# CITY OF ALBUQUERQUE

**RE: 64<sup>th</sup> Street Subdivision**  
**4221 64<sup>th</sup> Street NW**  
**Grading and Drainage Plans**  
**Engineer's Stamp Date: 08/06/2025**  
**Hydrology File: F10D067**  
**Case # HYDR-2025-00294**

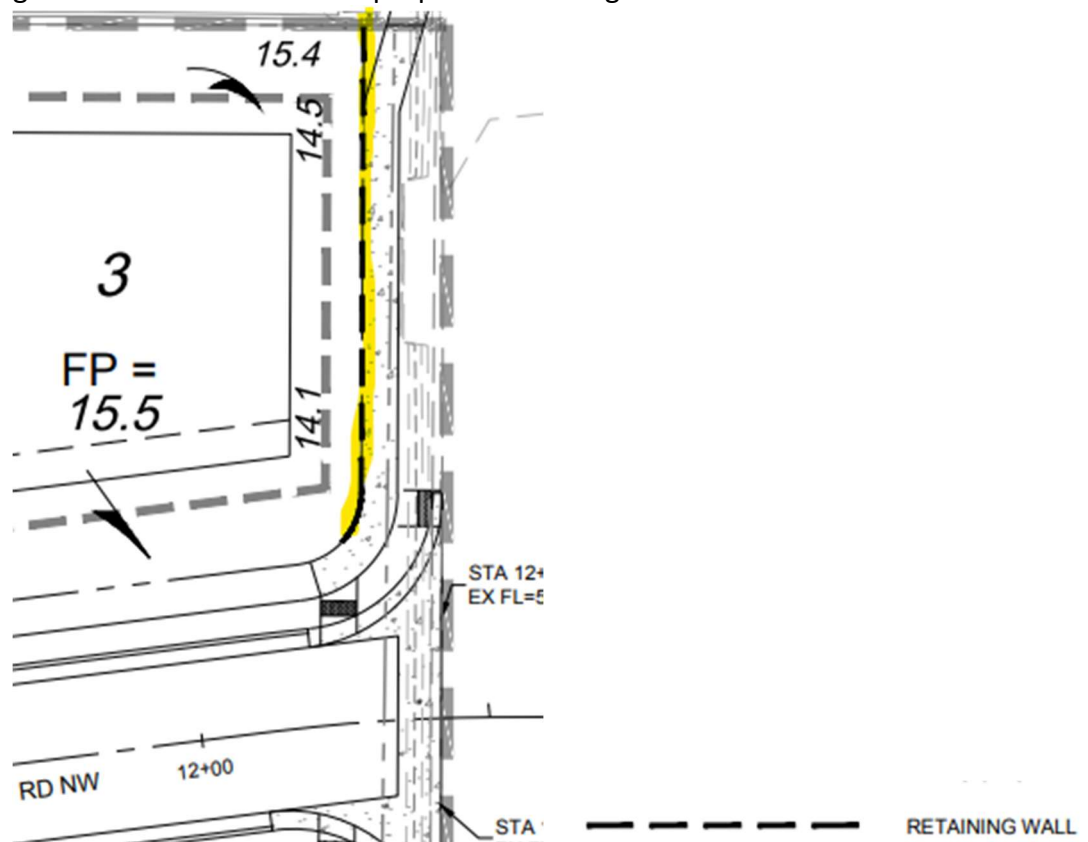
2. The Benchmark table is missing information

BENCH MARKS	
A SCRIBED "+" IN CONCRETE CURB NEAR THE WESTERN END OF THE PROJECT SITE, APPROXIMATELY 12 FEET WEST OF THE EDGE OF ASPHALT OF 86TH STREET SW AND 17 FEET NORTH OF THE EDGE OF ASPHALT OF AN UNNAMED ONE WAY ROAD.	
MODIFIED GROUND COORDINATES:	
NORTHING	= ###.###.## FEET
EASTING	= ###.###.## FEET
ELEVATION	= ####.## FEET (NAVD 1988)
